Access Compliance Report

Public Rights-of-Way

Intersection ID: N/A	Main Street: COVENTRY COURT LN	Cross Street: CASTLE ABBEY LN	Location: NW
ADA ID: D06D3C66C6EC	Ramp Type: PerpDiag	Initial Pass/Fail: Fail	Overall Compliance: No
		Severity Score: 22.5

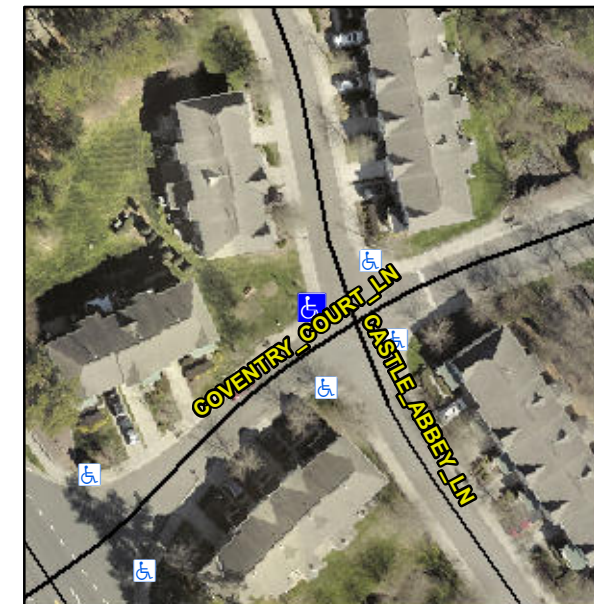
Not Found, R304.5.1, R304.2.2, R304.5.3

Compliance	Description	Data	Compliance	Description	Data
N/A	Ramp Length (in)	60.0	No	Ramp Slope (%)	8.4
No	Ramp Width (in)	46.0	No	Ramp XSlope (%)	4.0
N/A	Flare Type LT	N/A	N/A	Flare Type RT	N/A
N/A	Flare Slope LT (%)	N/A	N/A	Flare Slope RT (%)	N/A
N/A	Flare Traversable LT?	N/A	N/A	Flare Traversable RT?	N/A
N/A	Landing Length (in)	N/A	N/A	DWS Provided?	N/A
N/A	Landing Width (in)	N/A	N/A	DWS Contrast?	N/A
N/A	Landing Slope (%)	N/A	N/A	DWS Length (in)	N/A
N/A	Landing X Slope (%)	N/A	N/A	DWS Full Width?	N/A
N/A	Landing Curb? (Y/N)	N/A	N/A	DWS Offset (in)	N/A
N/A	Shared Landing?	N/A			
N/A	Gutter Ponding?	N/A	N/A	Gutter Slope (%)	N/A
N/A	Gutter Lip Ht (in)	N/A	N/A	Gutter X Slope (%)	N/A
N/A	Painted X Walk1?	No	N/A	Painted X Walk2?	No
	X Walk 1 Direction	To S		X Walk 2 Direction	To E
N/A	X Walk 1 Width (in)	N/A	N/A	X Walk 2 Width (in)	N/A
	X Walk 1 Slope (%)	1.5		X Walk 2 Slope (%)	0.4
	X Walk 1 X Slope (%)	0.8		X Walk 2 X Slope (%)	2.1

Remove & Replace Curb Ramp With Two New Directional Ramps or Equivalent.
